McCune Ranch

PRELIMINARY PLAN

SP-18-006

COVER SHEET

VICINITY MAP

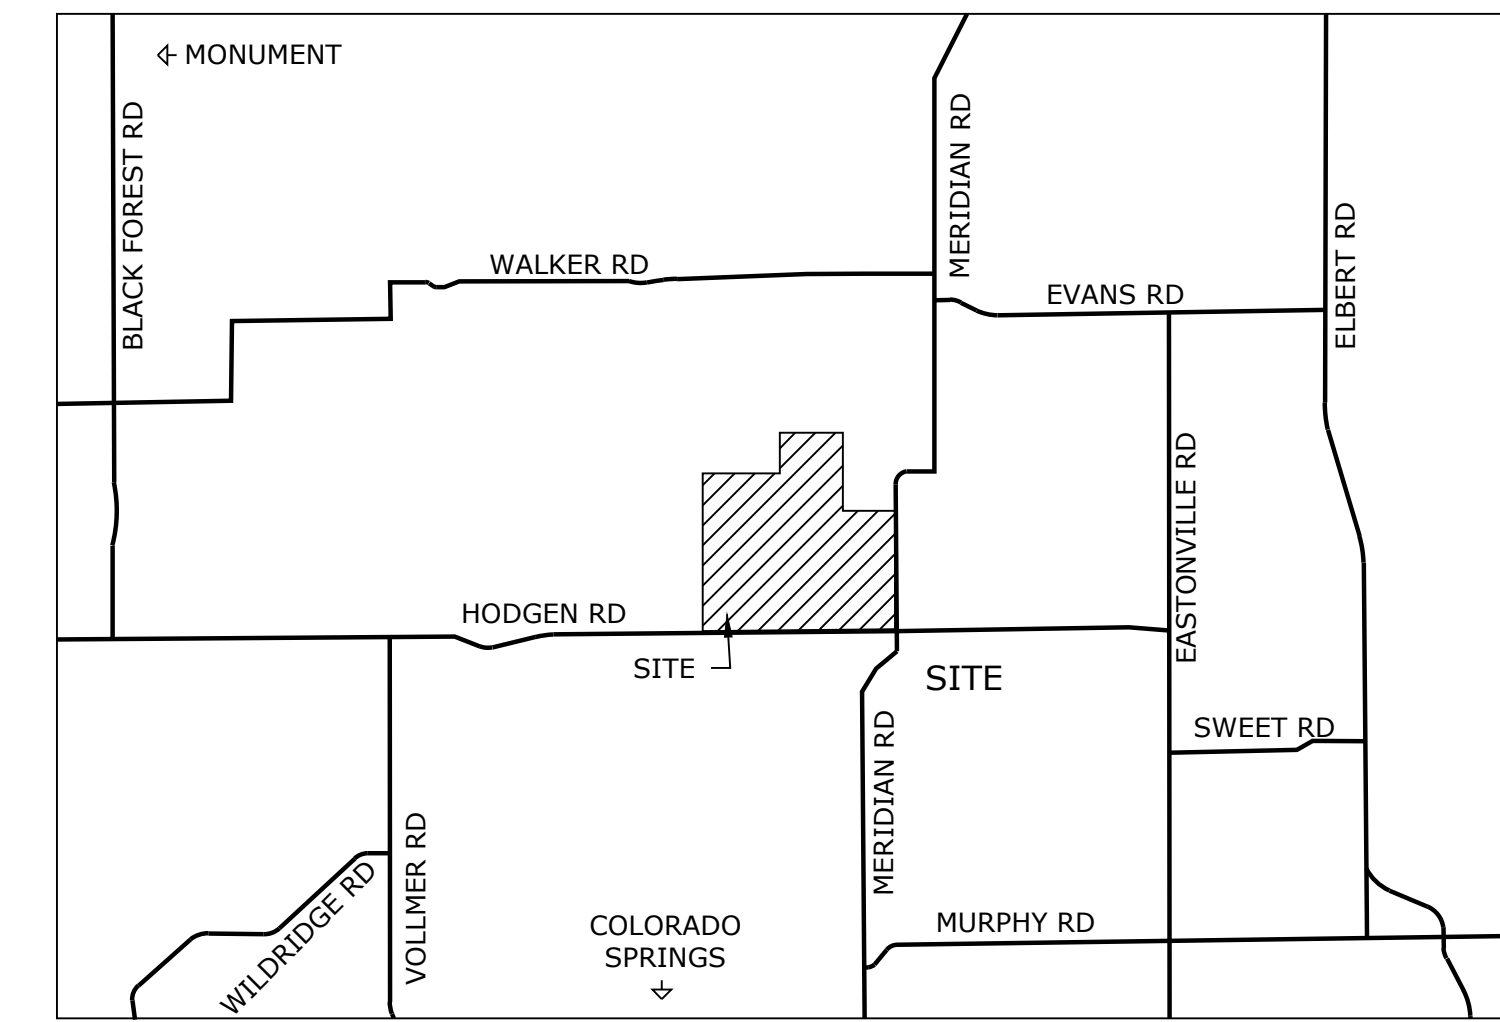
consider adding a note indicating if engineered foundations/site plans will be required.

add a note for typical utility easements.

Spell out PIE and PUE or provide an abbreviation list.
Add a note explaining why the applicant is providing a 10' public improvement easement instead of the standard 5'.

Callout the Hot Mix Asphalt and Aggregate Bas Course

incorrect, please revise

ZONING PLAN

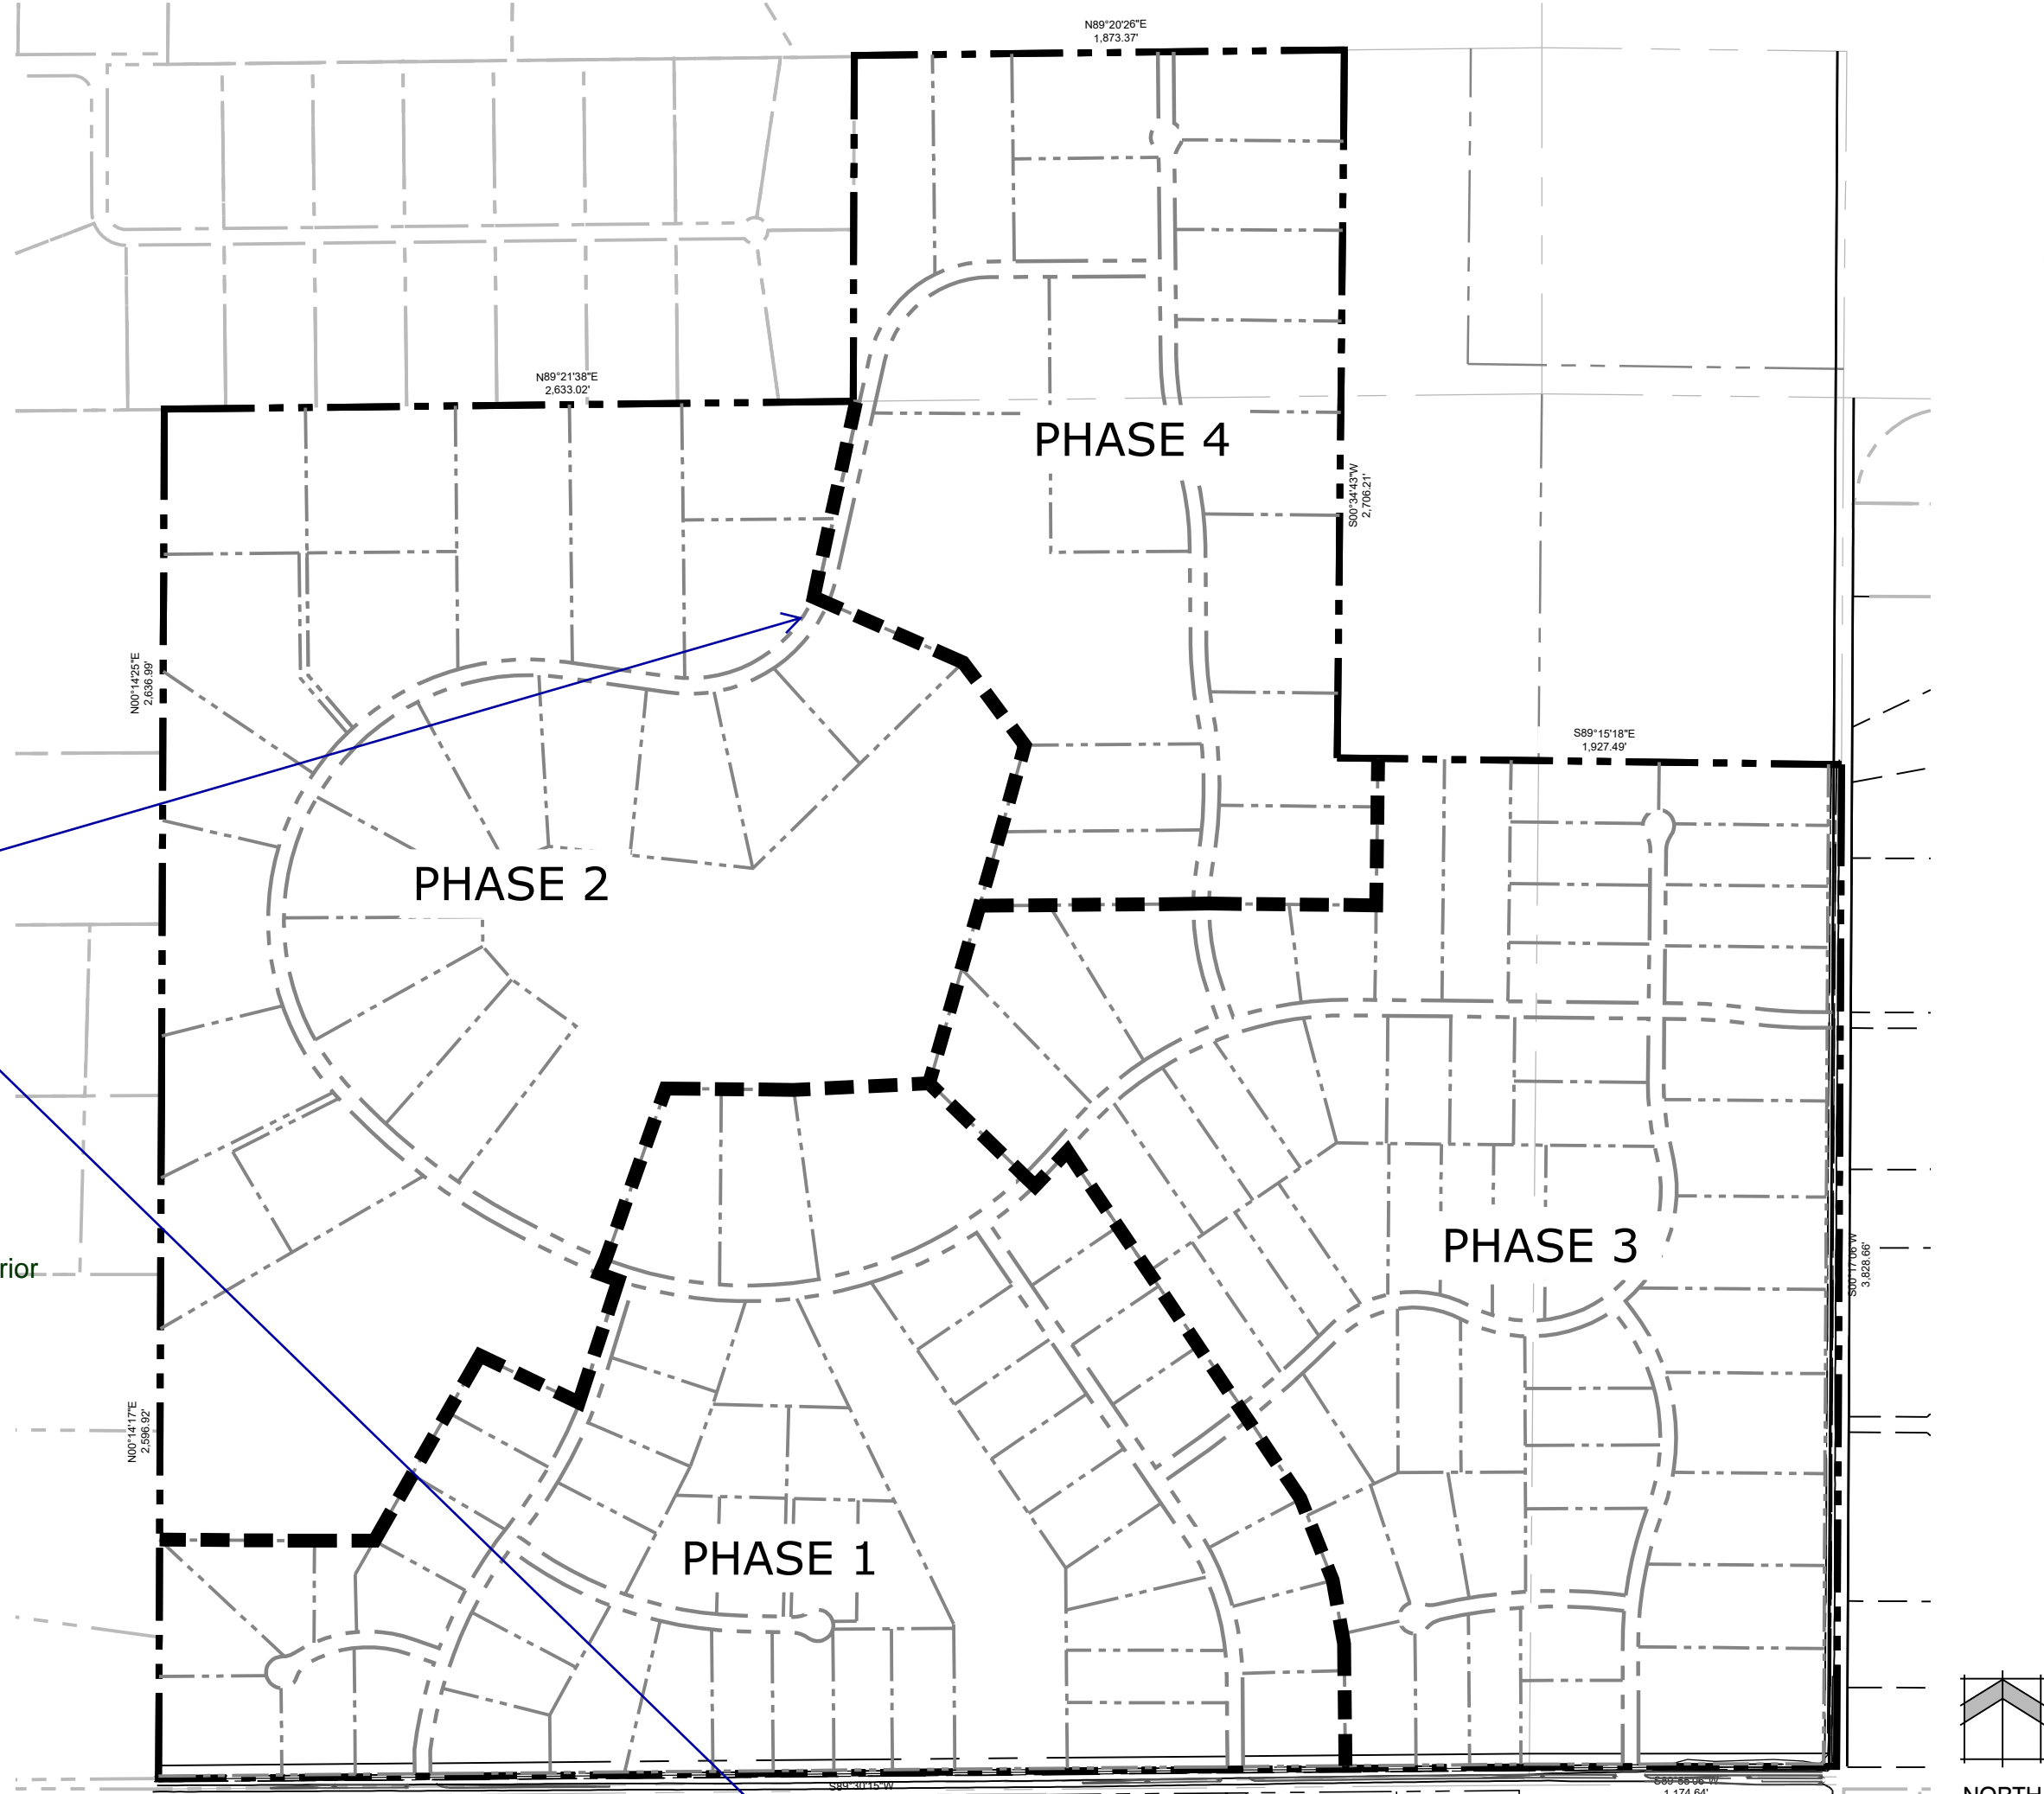
consider rezoning this portion RR-5 to act as a buffer between the existing development of RR-5 and A-35 zoning district (note that many of the proposed parcels along the eastern boundary are 5 acres.

PHASING PLAN

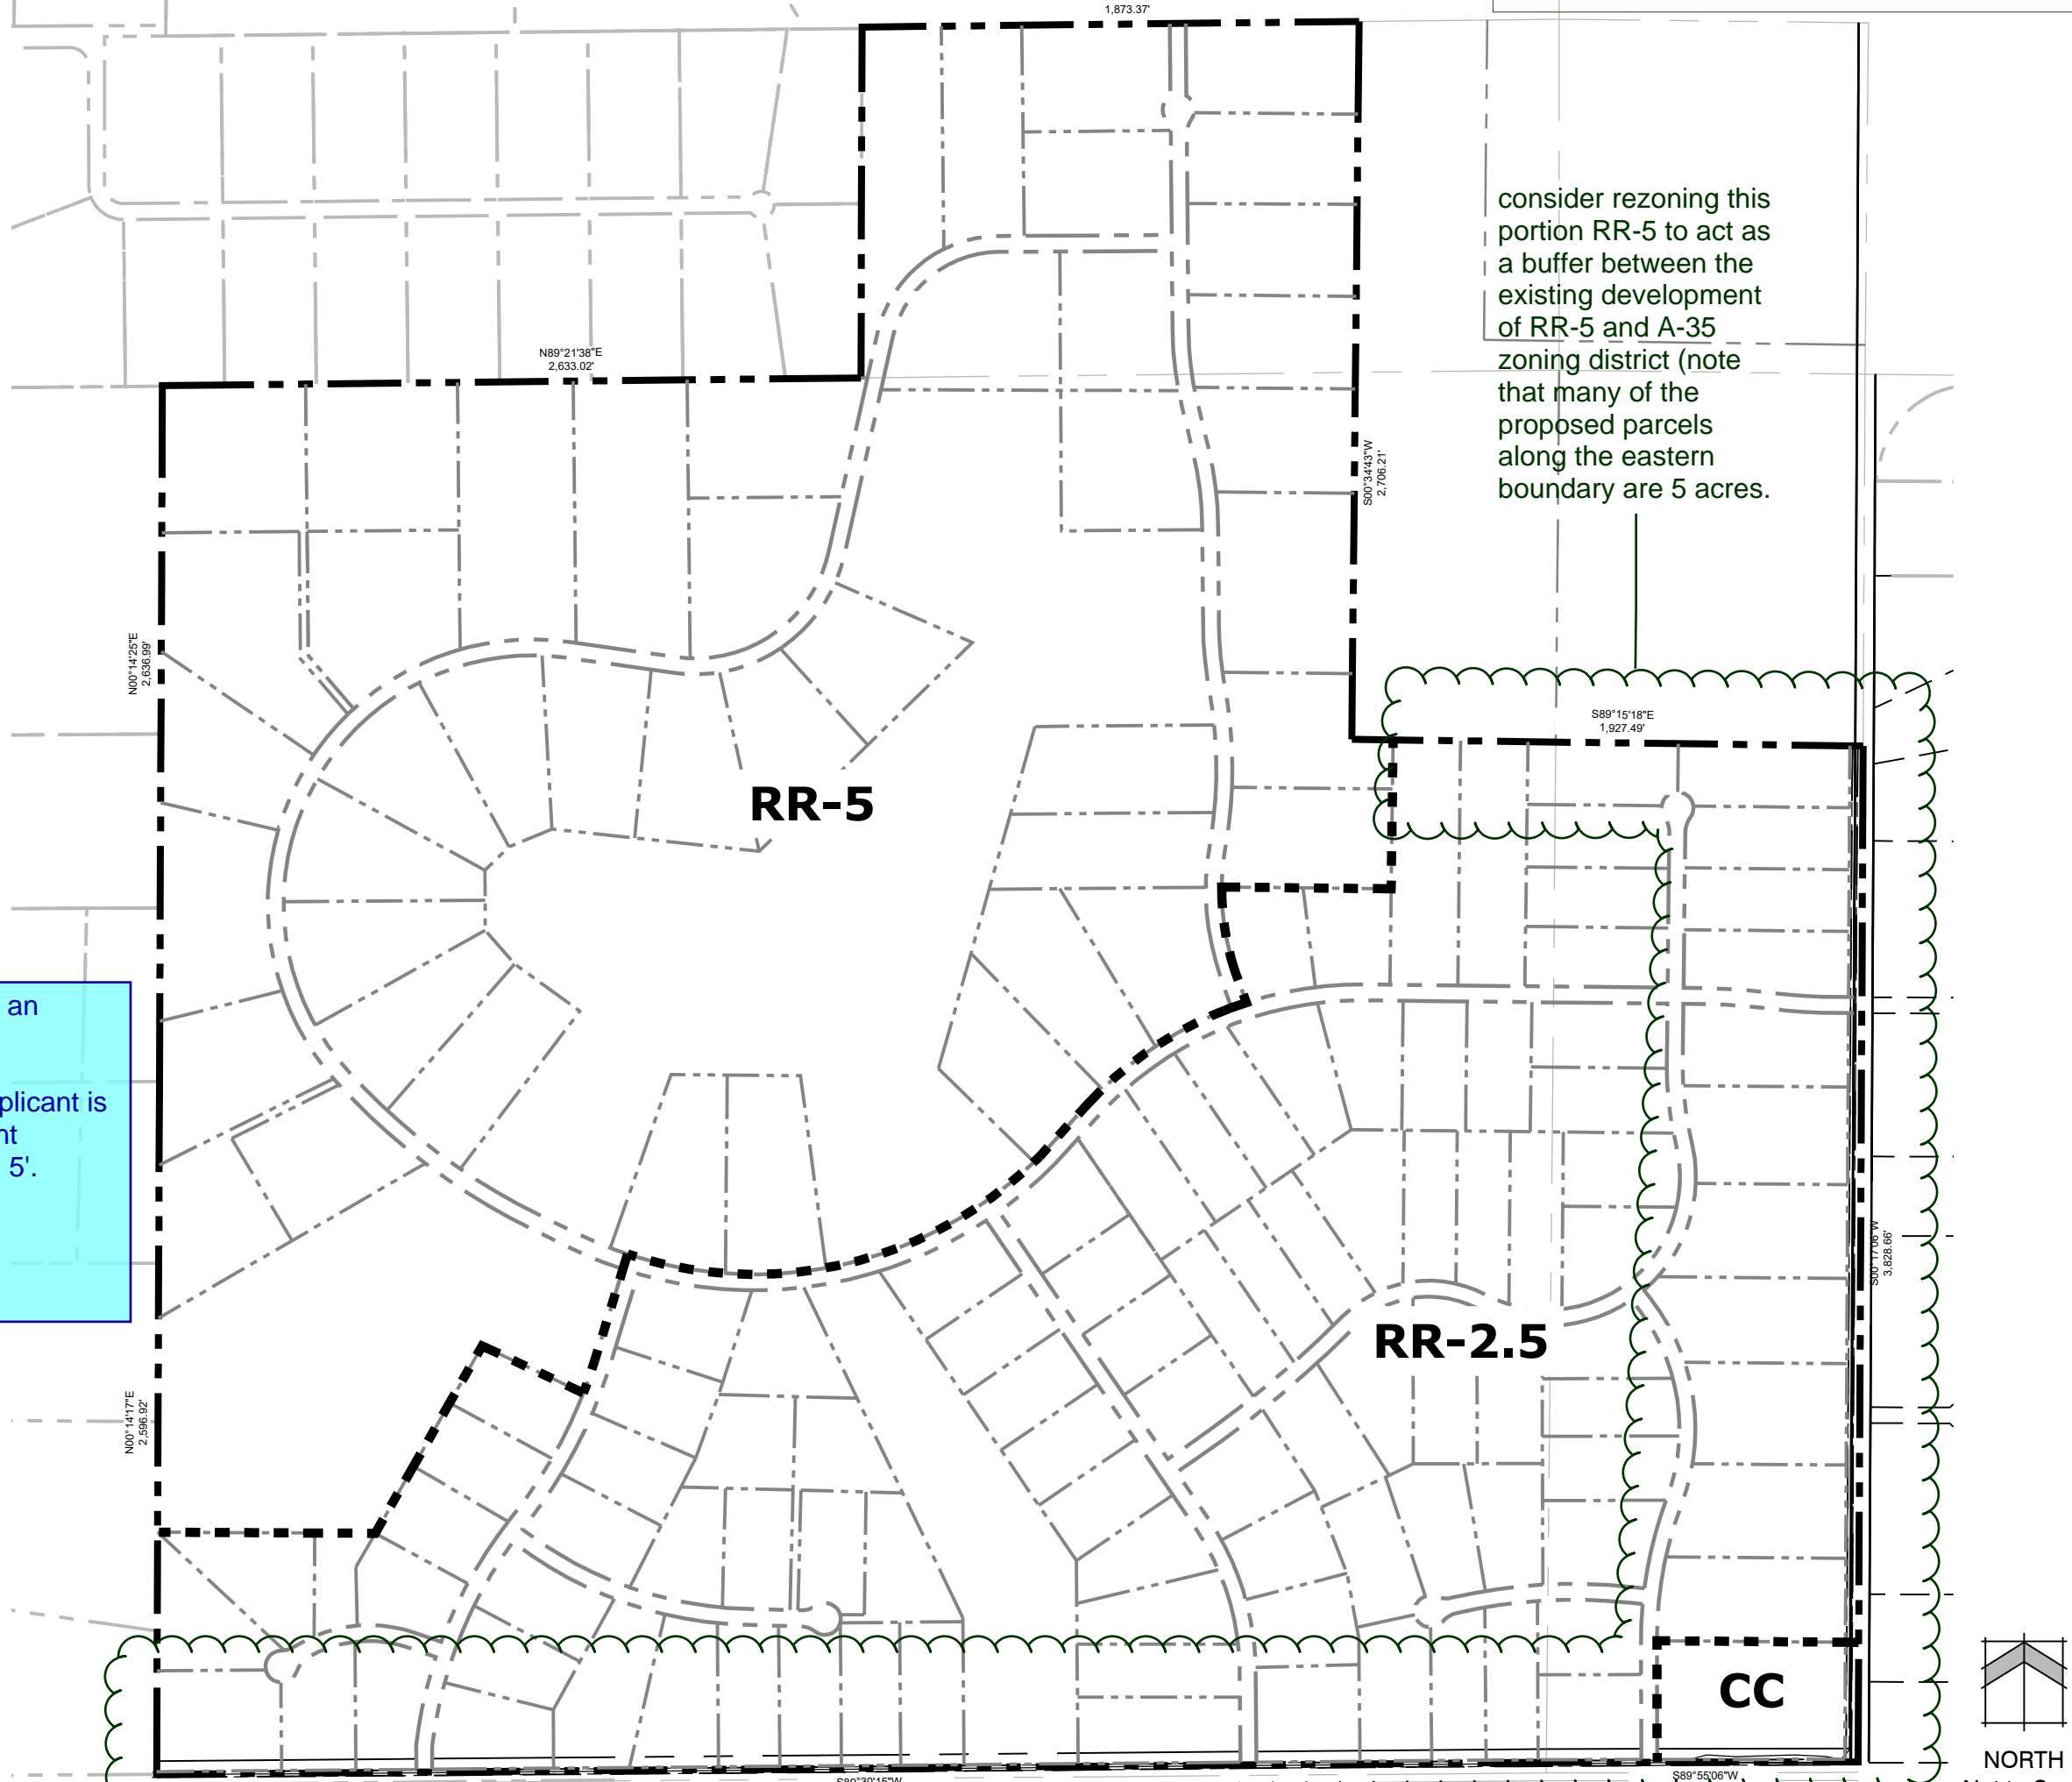
Based on the phasing plan this exceeds the maximum length for a cul-de-sac during phase 2. Update the public improvement for the phasing improvements and/or submit a deviation request. A deviation for the maximum cul-de-sac length will not be considered unless a written endorsement from the Fire District is included.

consider platting the entire drainage/open space area as one tract with phase 1 versus separating it into multiple phases.

recommend revising statement to allow for the market to dictate phasing so that if the actual phasing lines are slightly adjusted (adding 3 lots, or removing 3 lots) you do not have to amend the preliminary plan.
